10219 Land at Valley Park, Didcot

Technical Note 37: Southern Access – Response to planning committee NMU Crossing Options

26th April 2021

Figure 2-3- Proposed 5 arm roundabout layout (extract Brookbanks drawing ref 10219-HL-61-100-004 E)

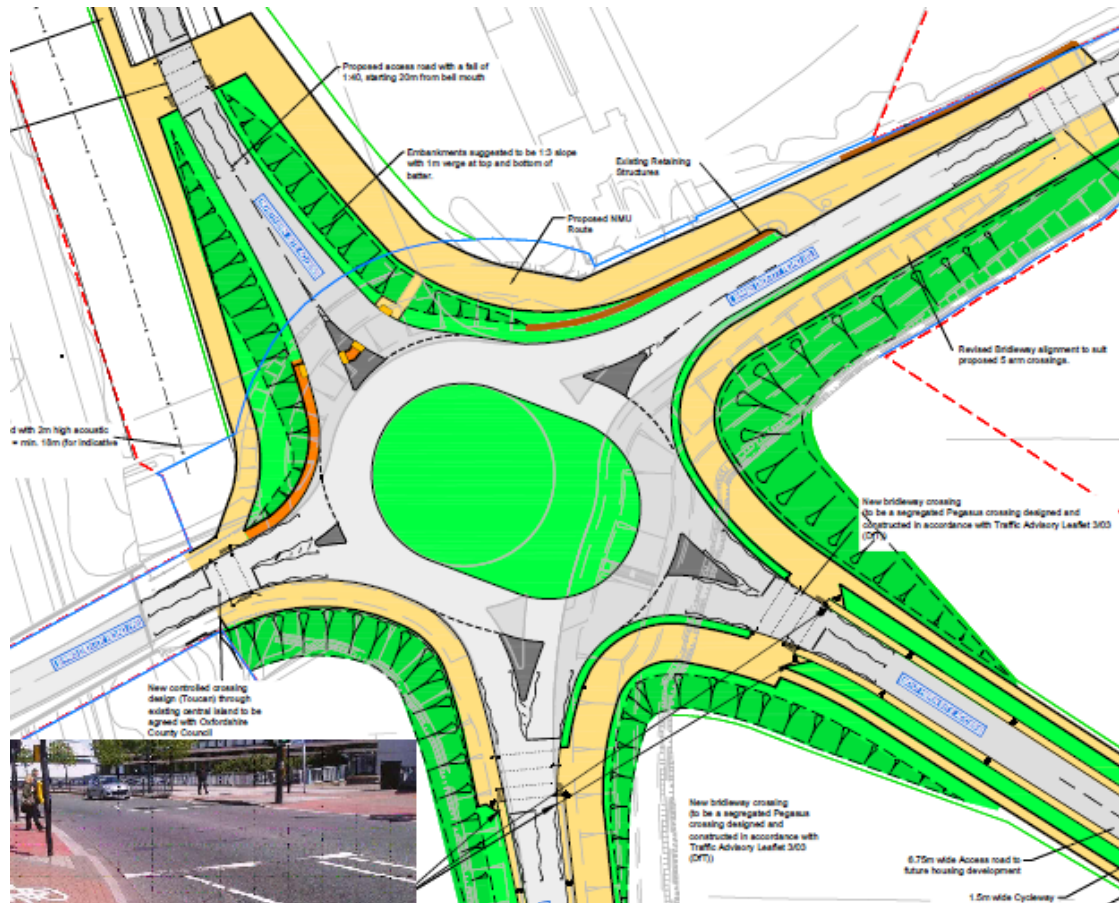
2.8 The red line boundary extent (shown in red dashed line) and requirement to provide a noise bund to the west of the northern link road are additional constraints that require consideration in the design proposals.

- 2.33** As a result of the meeting and the findings of this review the designers have further considered alternative options for NMU provision at the roundabout. The resultant design is shown in Figure 2.3 and discussed in further detail in TN 36. An additional controlled crossing has been included on the Harwell Link Road and crossings have been moved closer to the roundabout to reflect desire lines. Enhanced provision has been considered for the NMU's to improve the journey through the roundabout. Based on our review the **at grade crossing solution** with enhanced crossing facilities would appear to be the preferable solution for safe passage of the NMU's.

Figure 2-4 East – West Underpass Issues

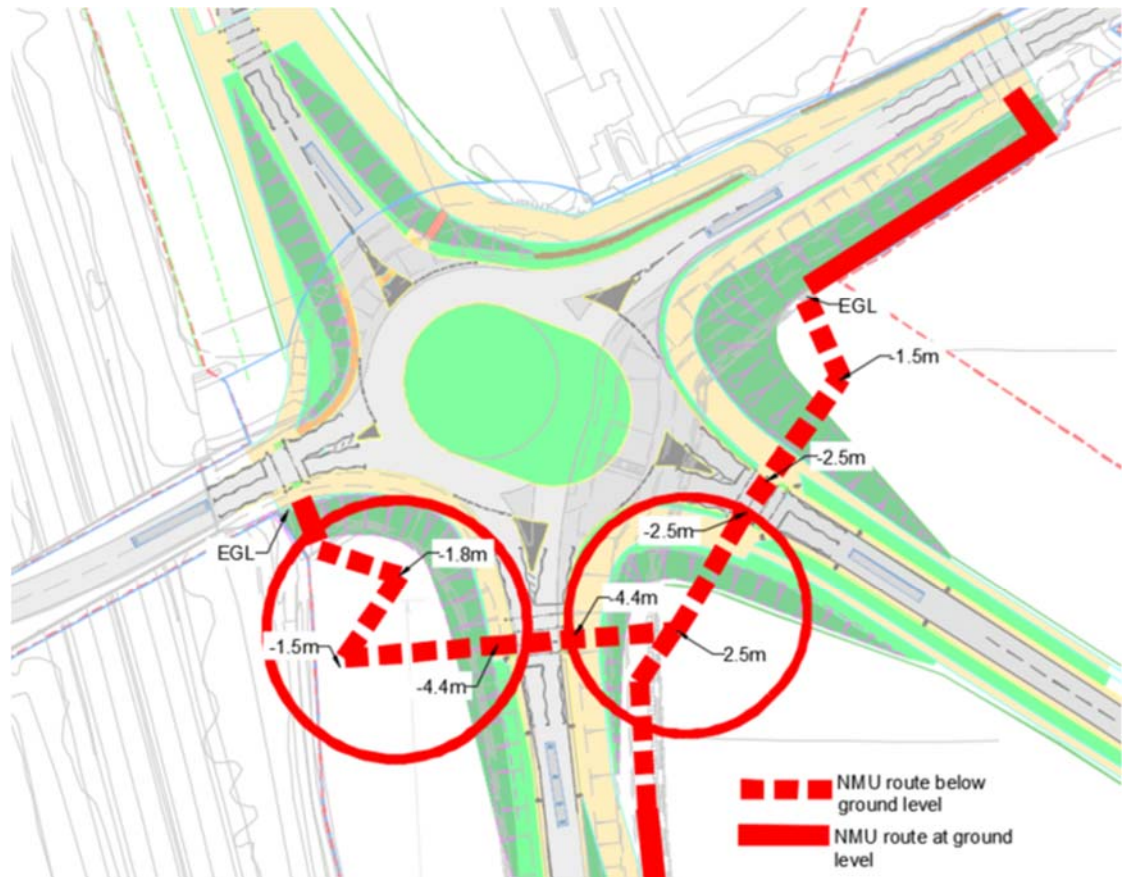
- 2.15 Figure 2-4 highlights the level issues with a potential east- west underpass route arrangement designed to accommodate DDA and DMRB criteria. The dashed lines indicate where the route is set over 1m below ground level and the areas circled highlight spaces that would become enclosed by retaining due to the proposed arrangement and existing topography. The level differences highlighted are relative to existing topography.

Figure 2-5 East- West Bridge Ramping Requirements

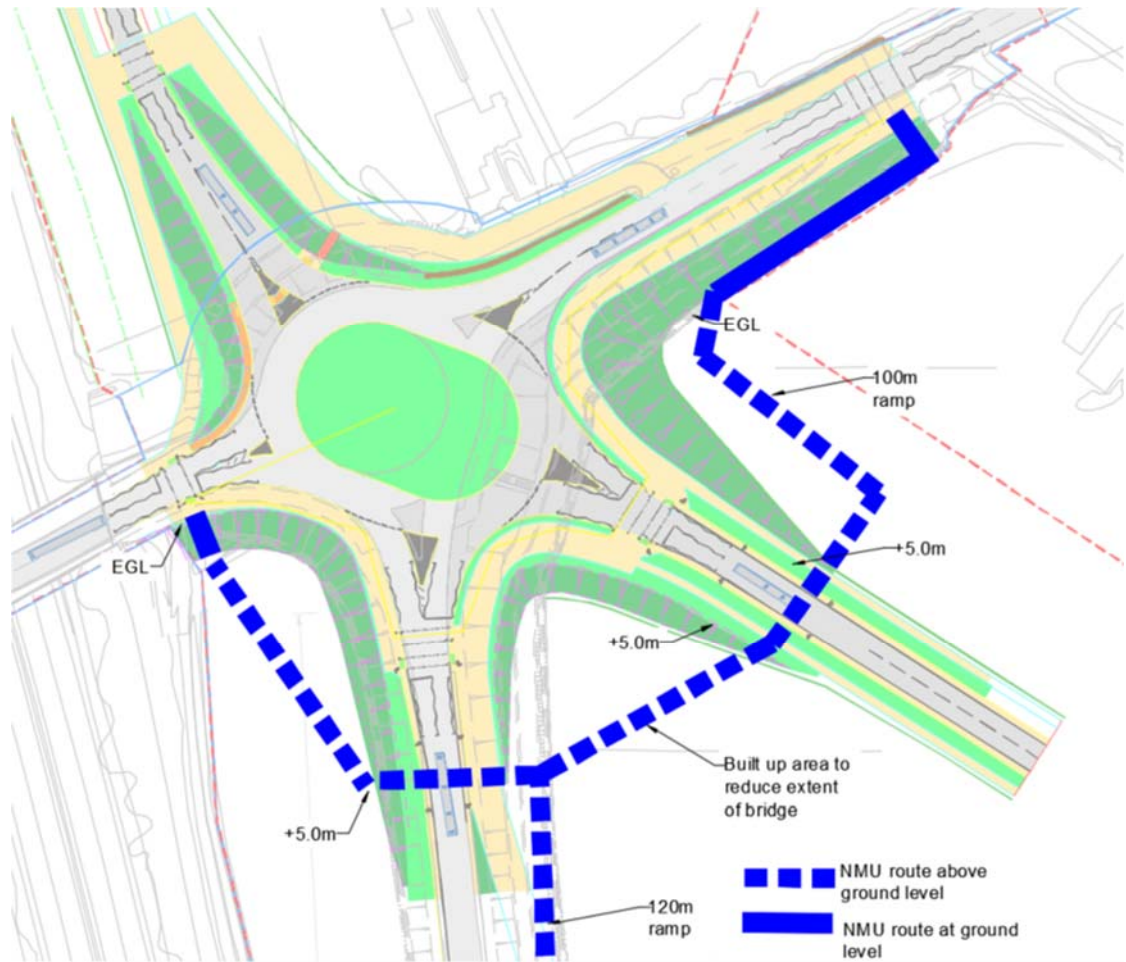
- 2.25** Figure 2-5 below highlights the extensive ramping in a potential east west bridge arrangement required to achieve required headroom and remain DDA compliant. A north south route would require a similar extent of ramping.

Figure 2-6 Dutch Style Roundabout Option

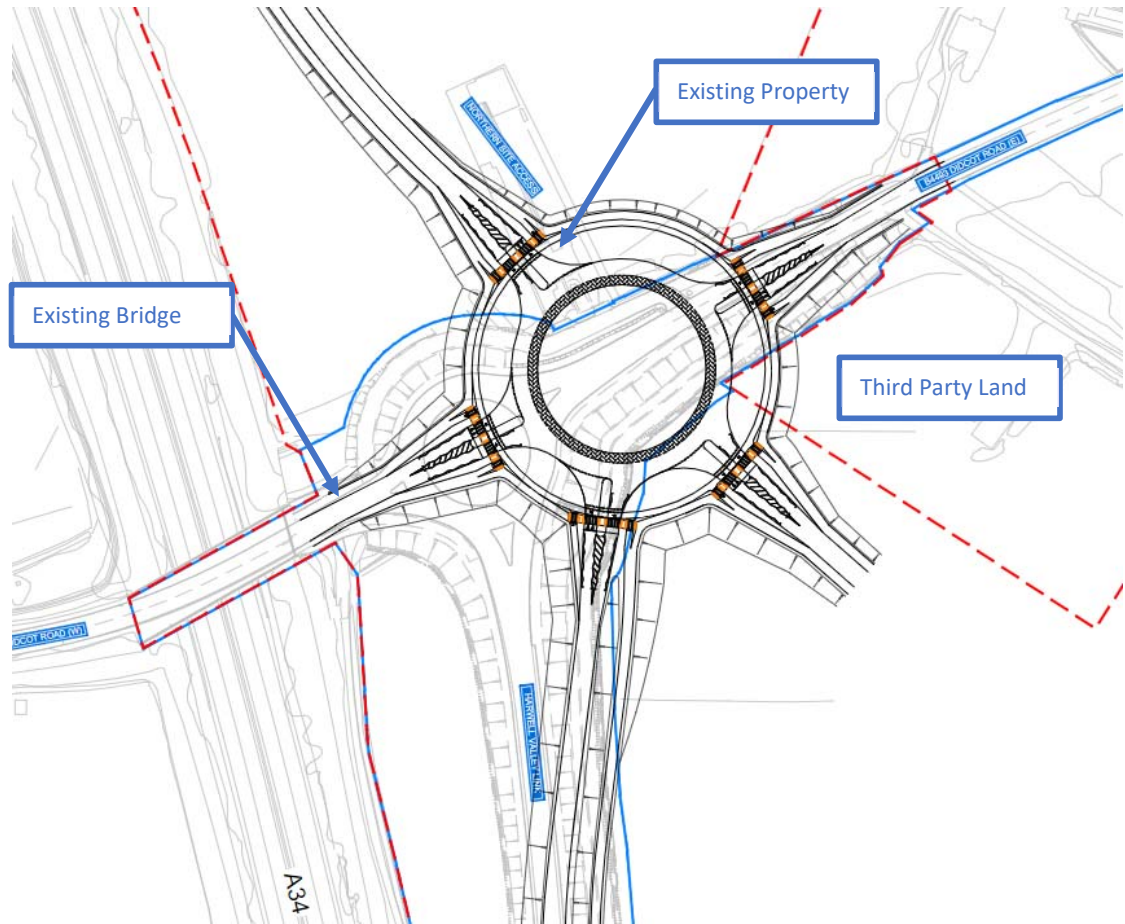
- 2.28 A Dutch Style roundabout option is presented in Figure 2-6. The design includes a circulatory route for cyclists alongside the zebra style crossing for pedestrians. Where the route forms part of the bridleway a Pegasus crossing will be required. Space is provided between the entry and exits and crossings to accommodate waiting vehicles. This option shown is a high-level design subject to traffic modelling, therefore the extent could increase. However, it can be clearly seen with the layout shown that the footprint required to accommodate this design encroaches on areas outside of the site boundary including existing properties and therefore is not an option for the Valley Park Development.

2.29 Moreover, to give some context around the journey time saving of the Dutch style option compared to the current 5th arm design we have measured the two routes from east to west. The measurement shows the Dutch style is only some 30m shorter in length and therefore the impact on journey time for a cyclist or other NMU is inconsequential through the junction.

Suggested cycle / pedestrian / bridleway underpass

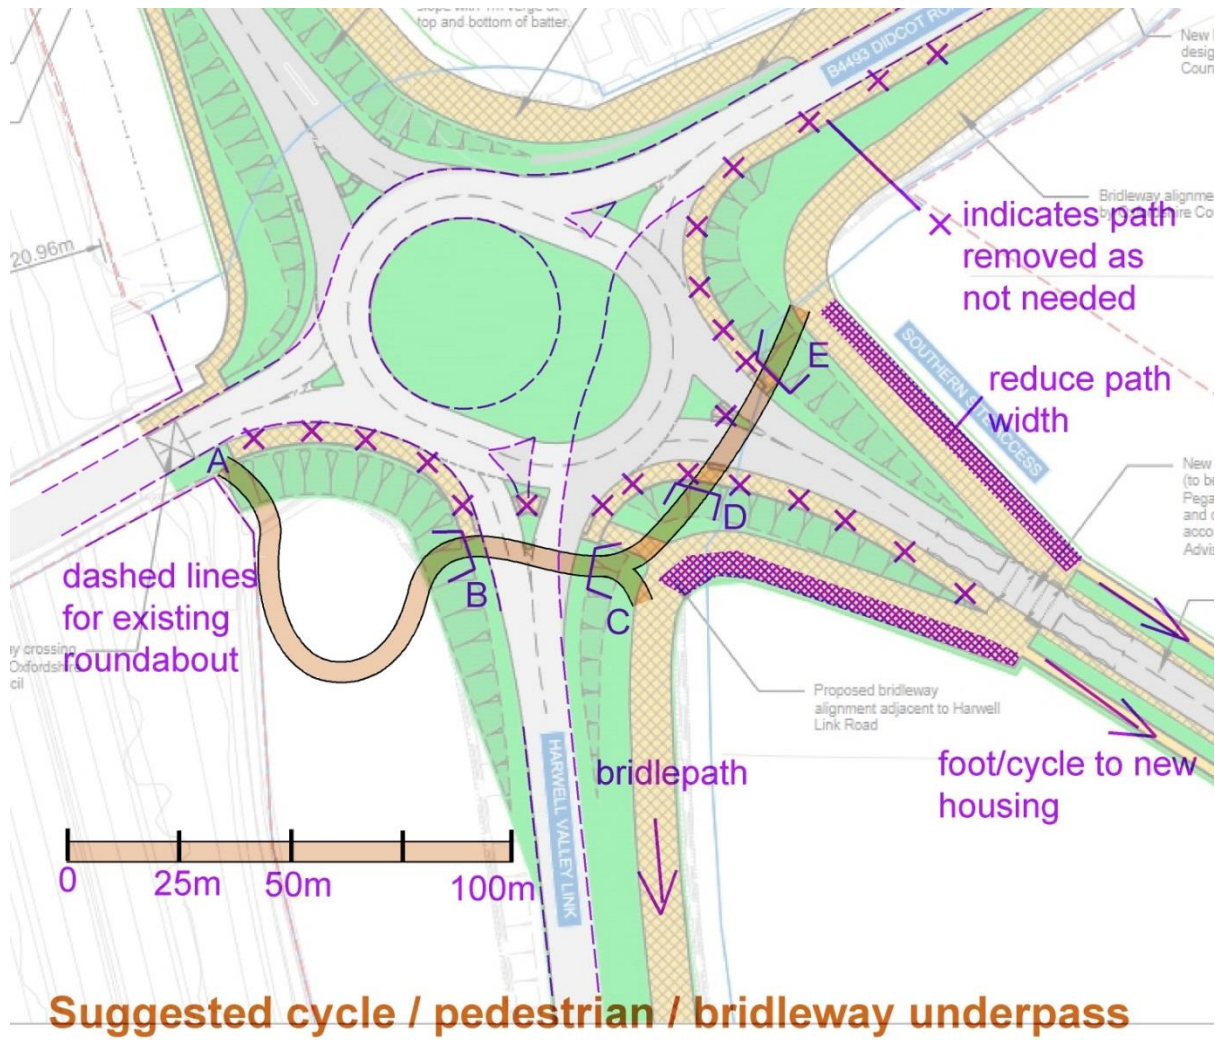
At the proposed Didcot Road roundabout, it looks feasible to put a pedestrian / bridle path under the link road and the new roundabout arm for the Valley Park development. Taking the plan from the proposal, the figure below has a 5-metre wide path added along line A-B-C-D-E which has 2 underpasses, B-C and D-E:

The link Road is hardly changed in the proposal; its underpass is B-C. The distance A to B is about 50 metres, but putting in a loop as shown can increase this to 100m. A gradient of 5% then allows the path at B to be 5 metres below the path at A, where the route joins the Didcot Road over the A34.

The verge at B is very slightly above the path at A, but assuming they are level, the path entering the underpass at B could be 5m below the road surface, which is more than enough. The bridlepath route to the Driftway could then be immediately joined without the enormous detour either current or proposed.

Sections of path adjacent to the road would no longer be needed – as shown by the purple Xs, and the paths to the new housing would be just that, not a route to a bridleway crossing.

- 2.16** Note A shows a potential arrangement, unfortunately this would not work as shown due to the reasons set out above. Further review has found the plan shown is slightly out of scale, so length of route shown does not correctly reflect the length required to ramp down. It also does not consider the land take for retaining/embankments.

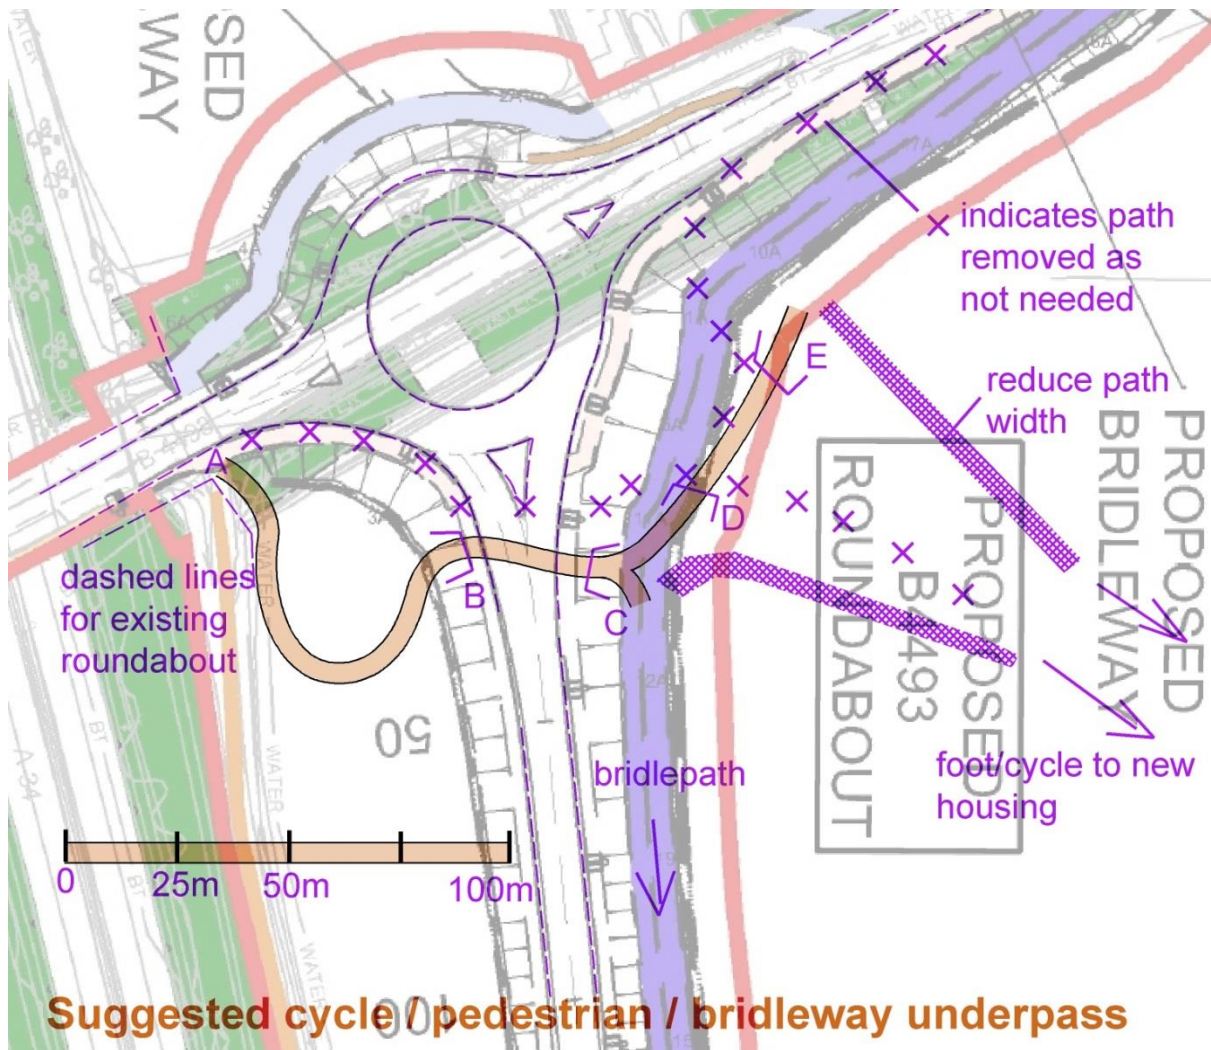
The next figure replaces the proposal plan for one of the current roundabout. I hope the figure isn't too confusing, with the extra annotation, but you can see that the underpass B-C emerges at C onto the current cycle path / bridleway route.

Looking down on the current path and bridleway beyond the fence from by the Link Road this is the view, on the left. Where the steps currently are, not shown on the original plan above, the cycle path and bridleway are 3.0 metres below the road verge. So to accommodate the underpass they would need to be lowered by maybe upwards of a metre, which doesn't seem impossible.
